TO: ALL PREQUALIFIED BIDDERS
INVITATION TO BID: Side Slope Closure – Bridgeway Acres Class 1 Landfill
BID NUMBER: 145-0282-CP(DF)
BID SUBMITTAL IS DUE: August 11, 2015 @ 3:00 PM

ADDENDUM NO. 2

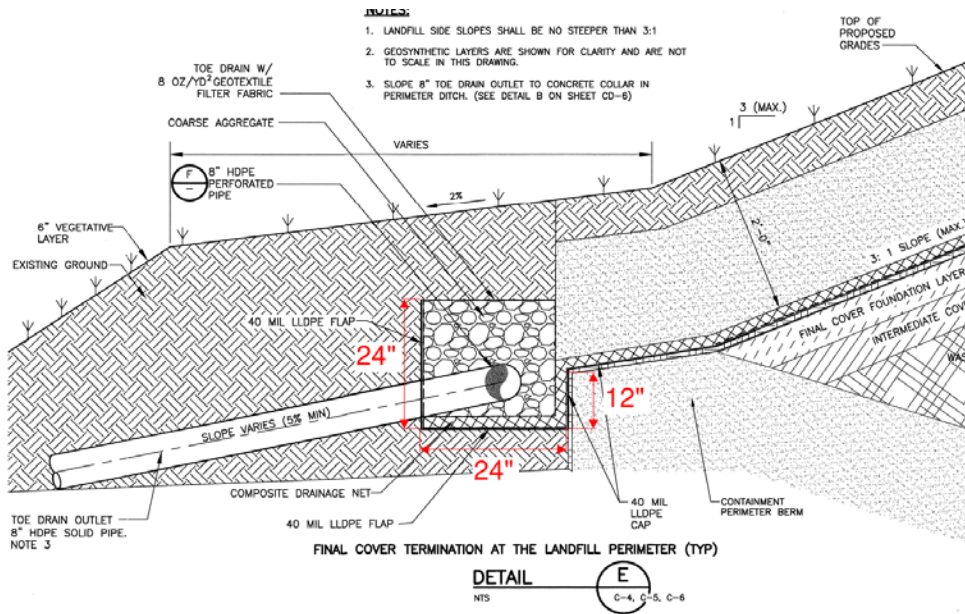
Per Dwg. CD-1, Detail E, this detail is not to scale. Please provide dimensions for the 40 mil LLDPE Cap and the 40 mil LLDPE Flap per this detail.

Refer to Detail B on Sheet CD-6. The dimensions of Detail E on Sheet CD-1 are also clarified in the markup below:
